ARTICLE 14 RESPONSE

Churchtown Landfill Site

IBR1015
Article 14 Response
Final
16 July 2019

Drawing Number	Rev
IBR1015/101	A

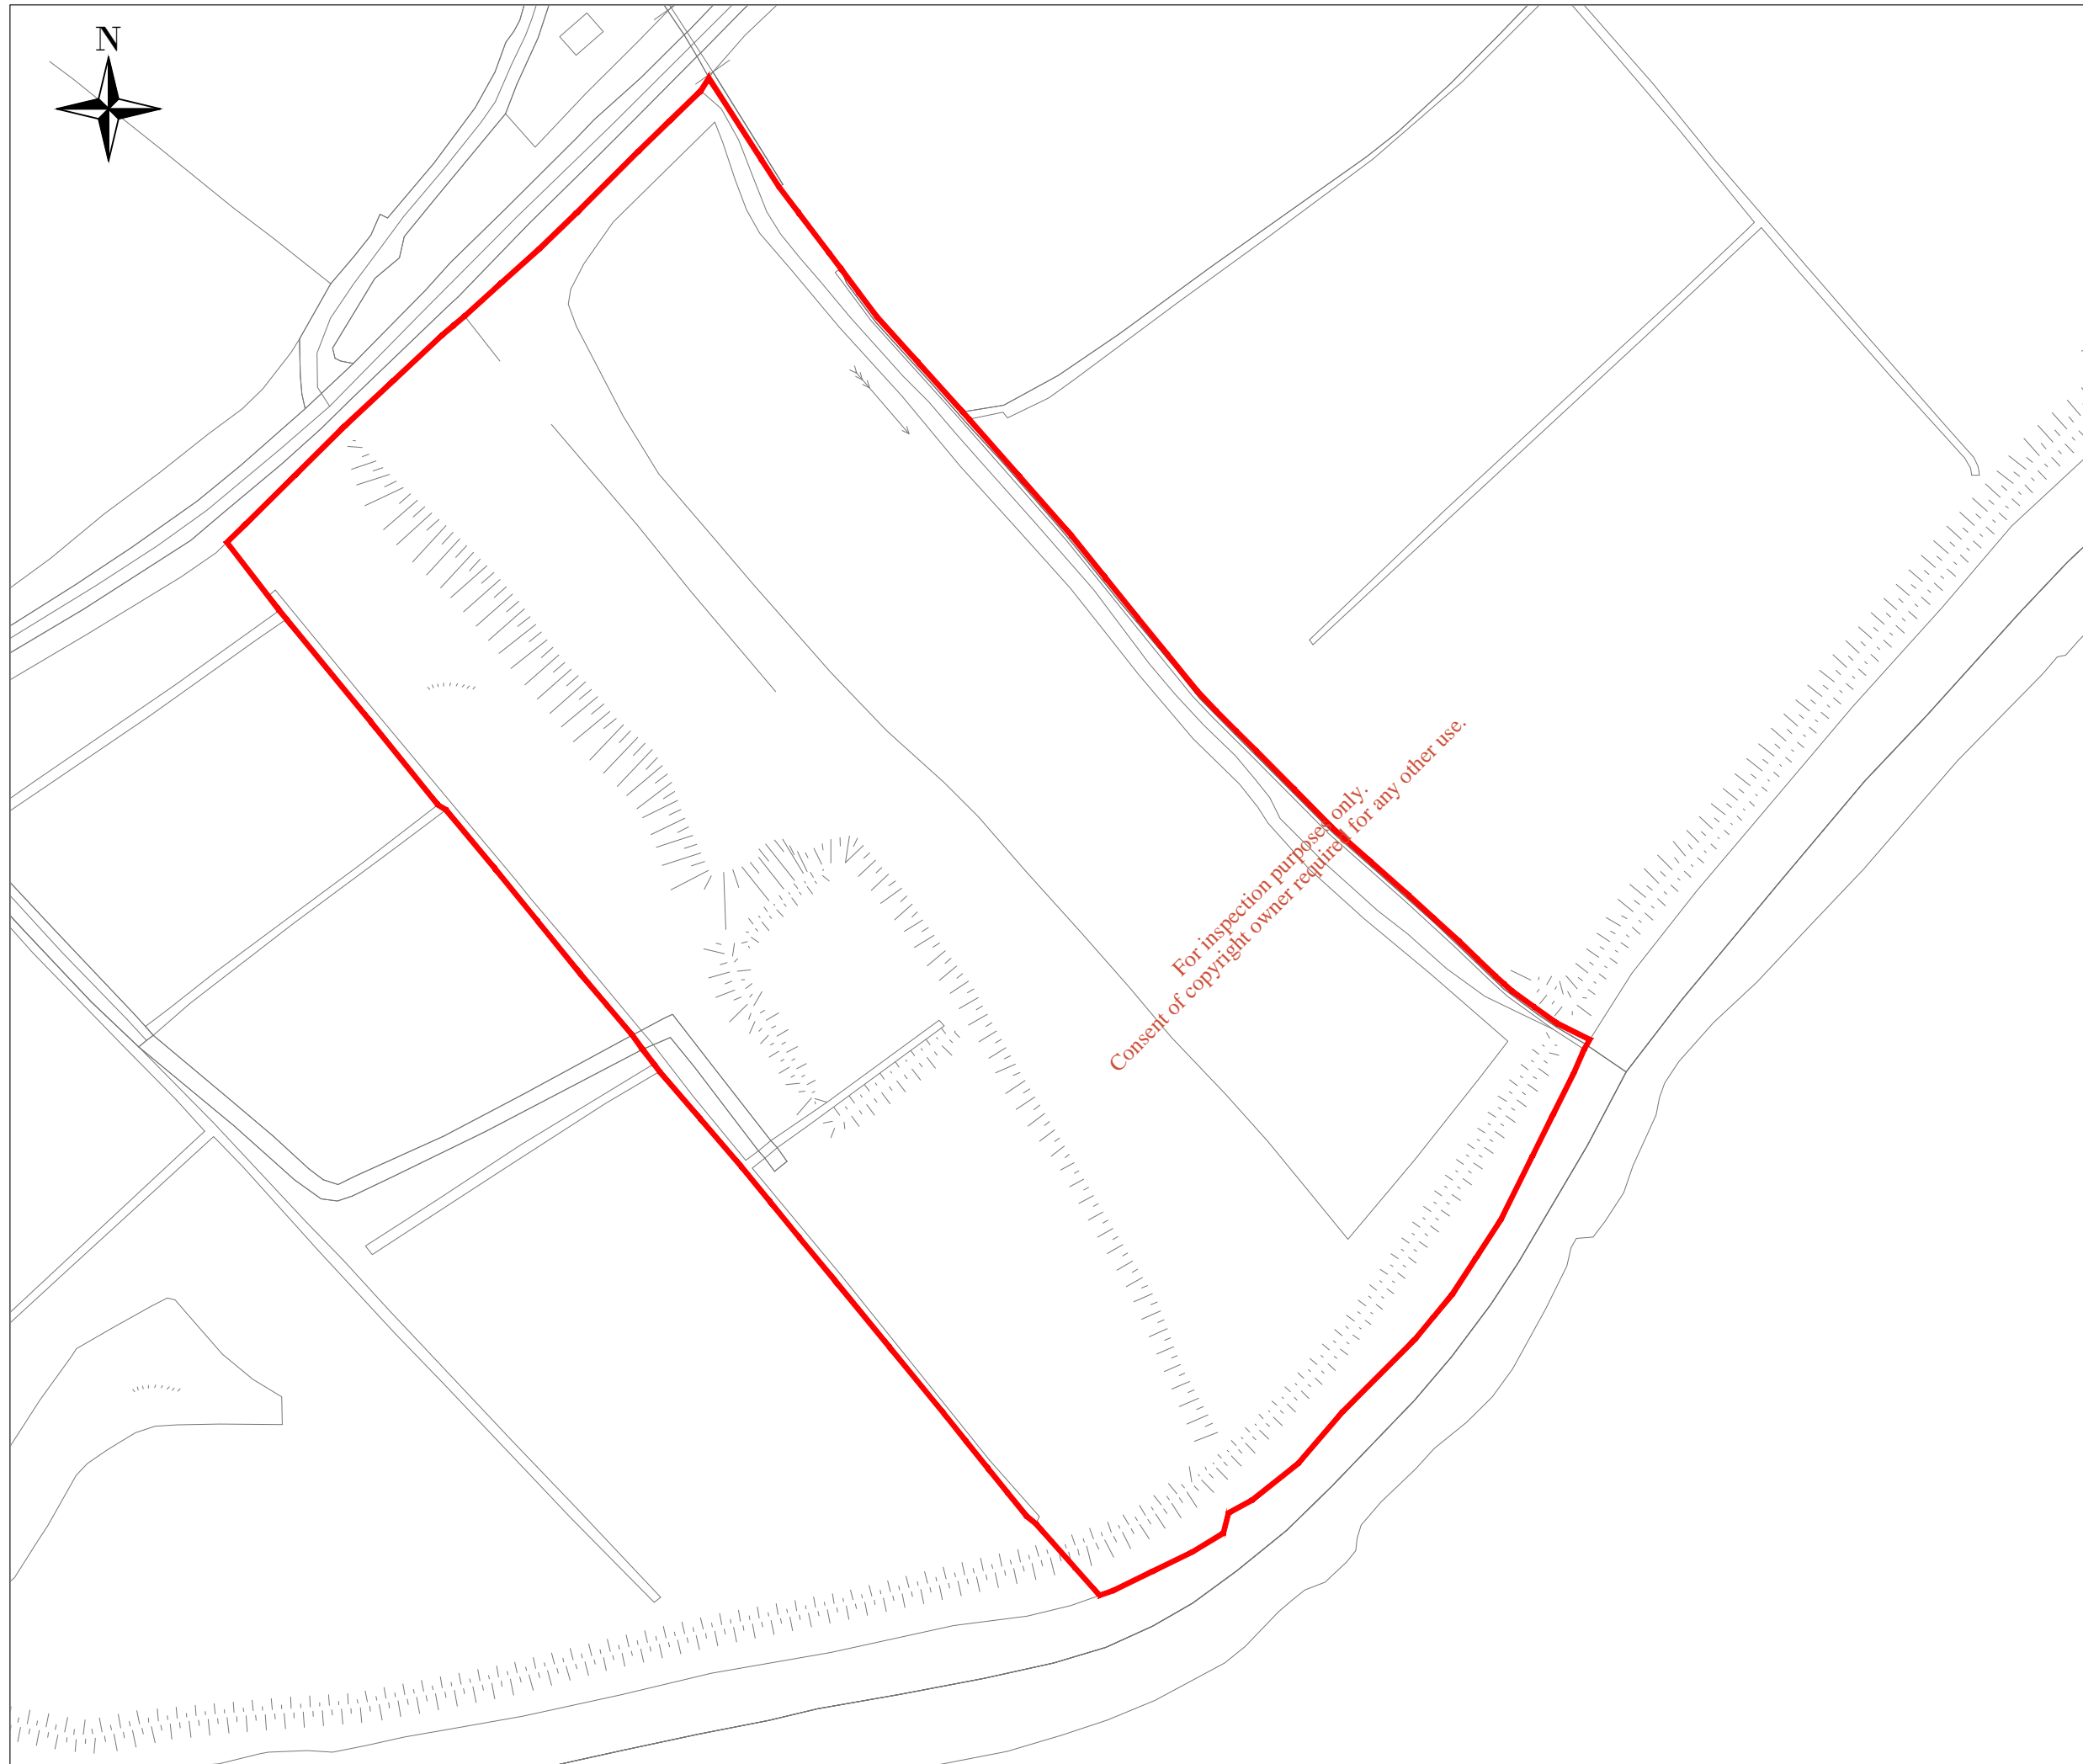
Submit a drawing showing the site boundary. The site boundary should be outlined as a continuous red line surrounding the entire facility.

Drawing IBR1015/101A Site Boundary is included in Appendix A.

Drawing Number	Rev
IBR1015/104	A

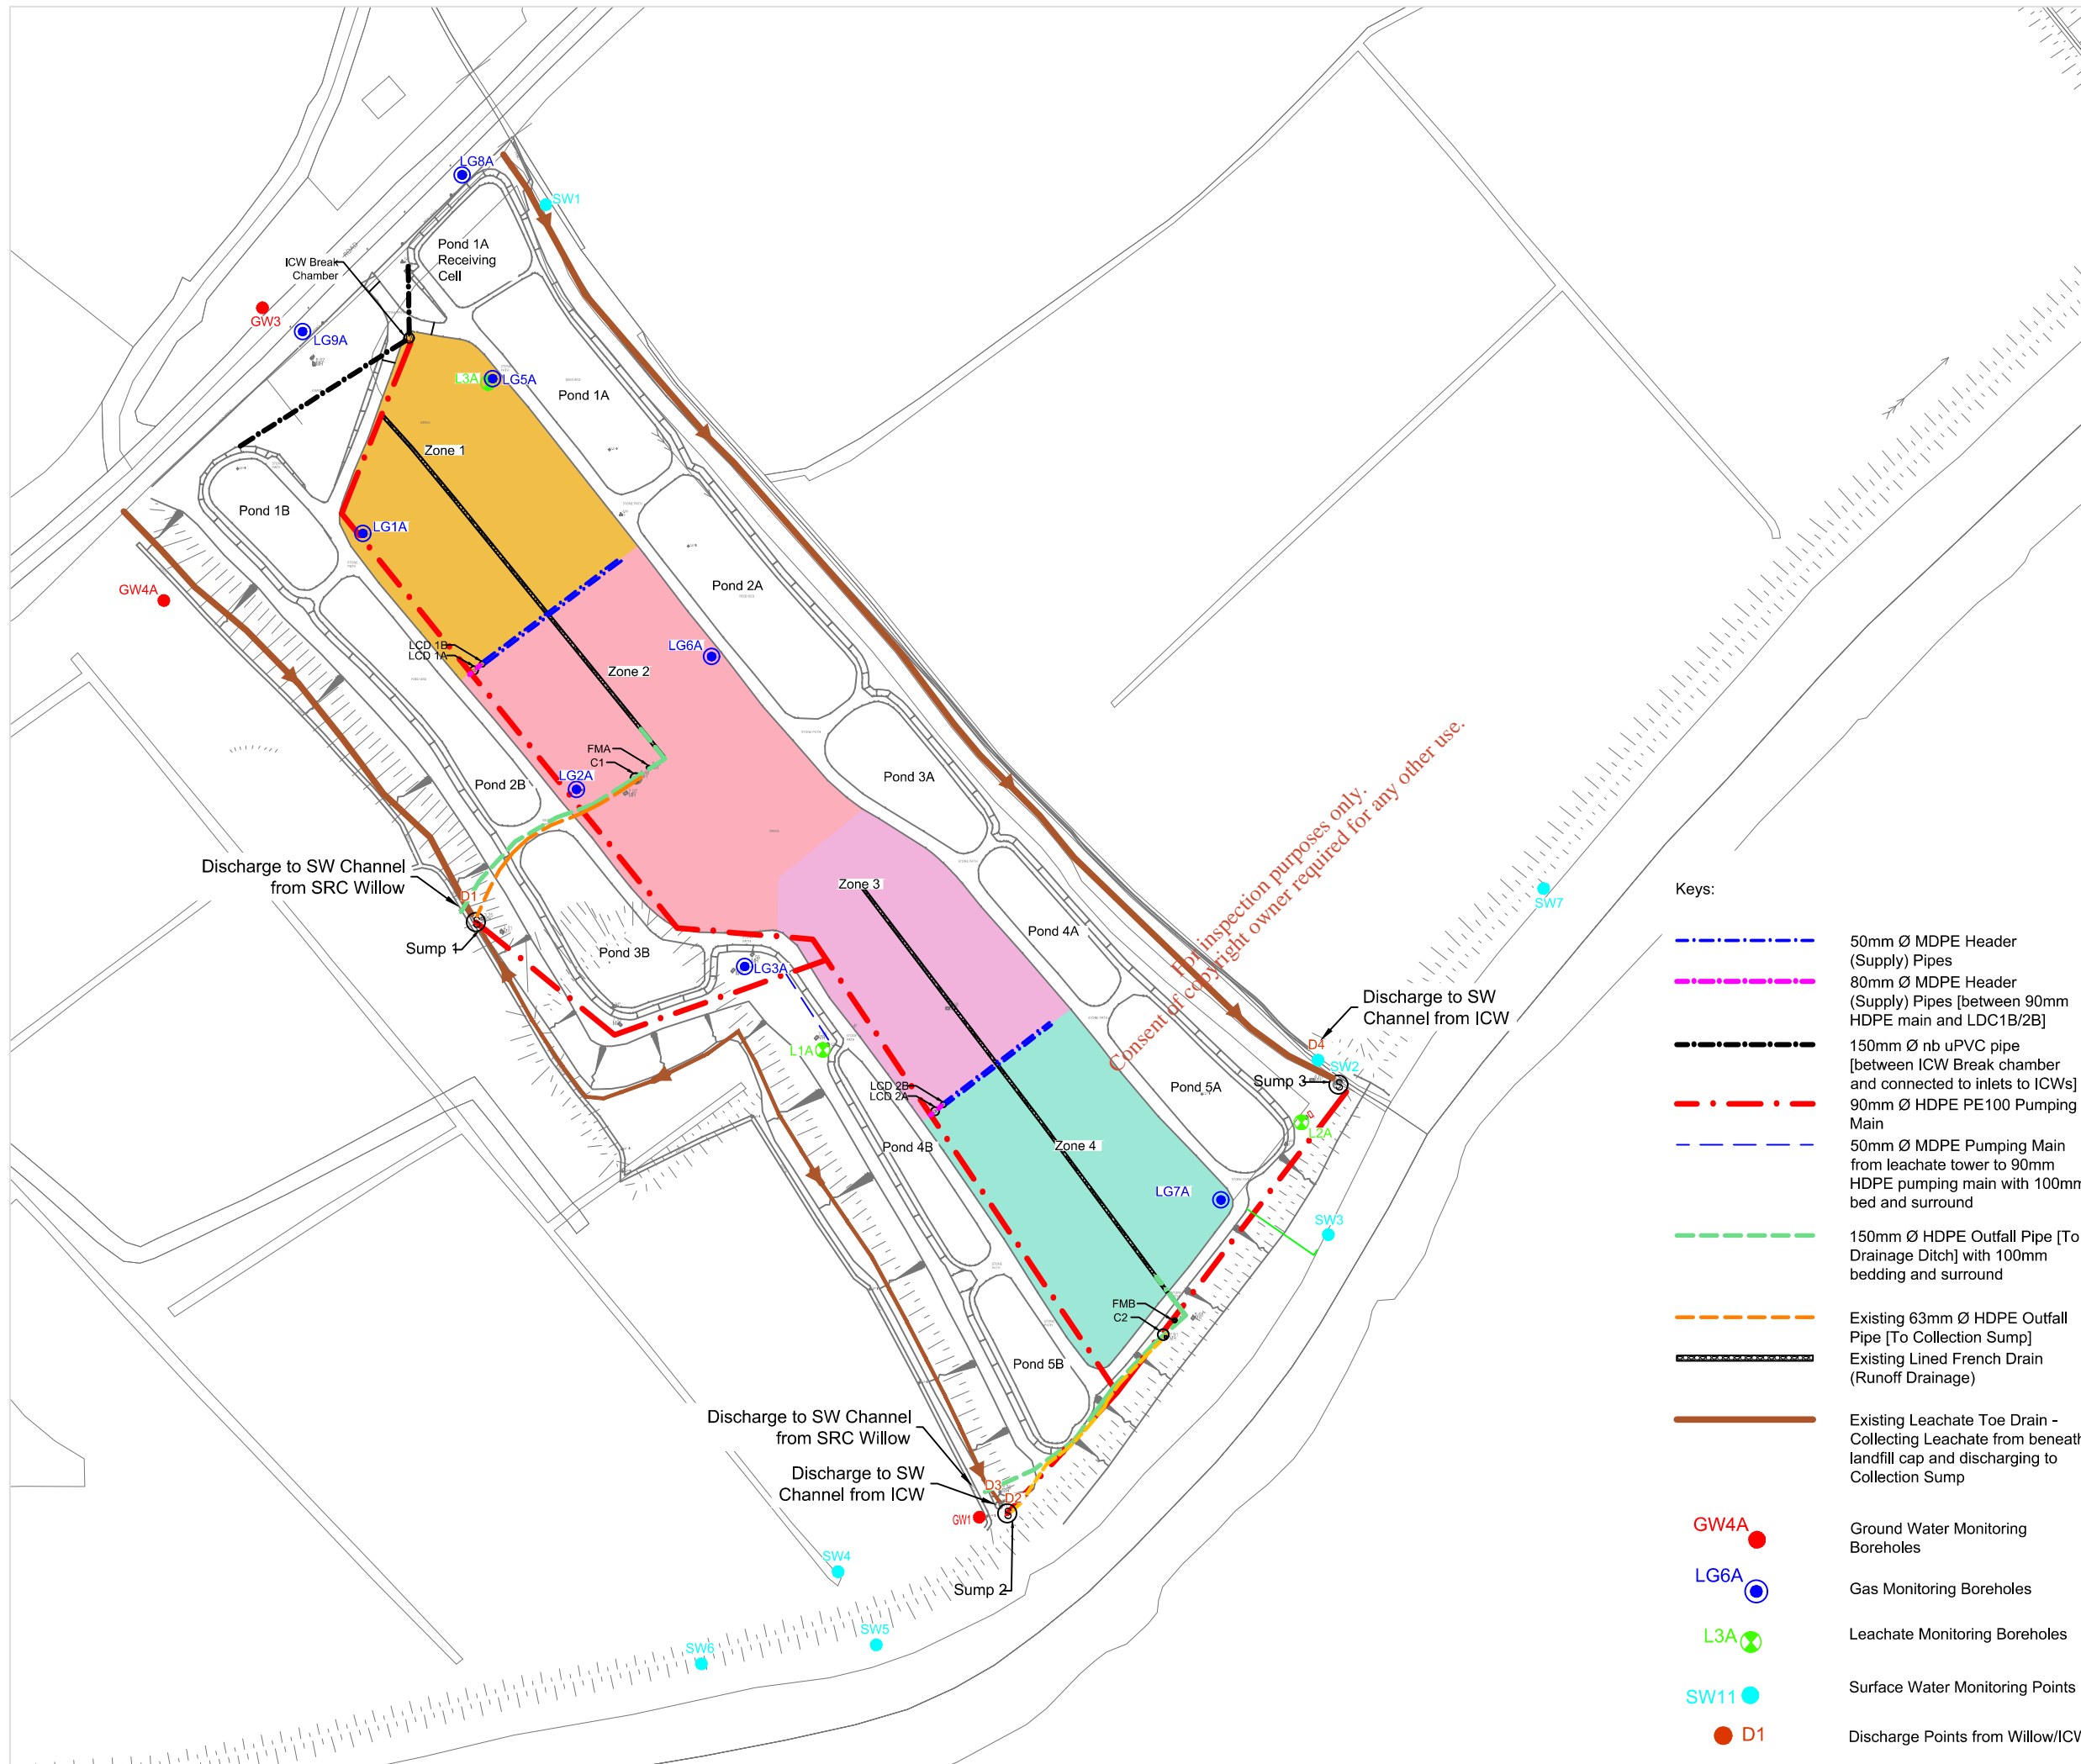
Provide a drawing that clearly shows the flow of the pumped landfill leachate through the willow plantation and the ponds. Include the locations where the treated landfill leachate discharges to the surface water channels and locations where the treated effluent discharges to the River Finn. Include symbols and grid coordinates (6E,6N) for each discharge location.

Drawing IBR1015/104A and IBR1015/106 are provided in Appendix A. Grid coordinates (6E, 6N) for each discharge location where treated landfill leachate discharges to the surface water channels is given in the Table 1.1 below.

Please refer to Drawing IBR1015/104A Churchtown Landfill Site Monitoring Locations for updated monitoring location. Treated effluent discharges to surface water channels and subsequently discharge to the River Finn at SW2 and SW5.

A	Discharge Points Added	MC	July '19
rev	amendments	drawn	date
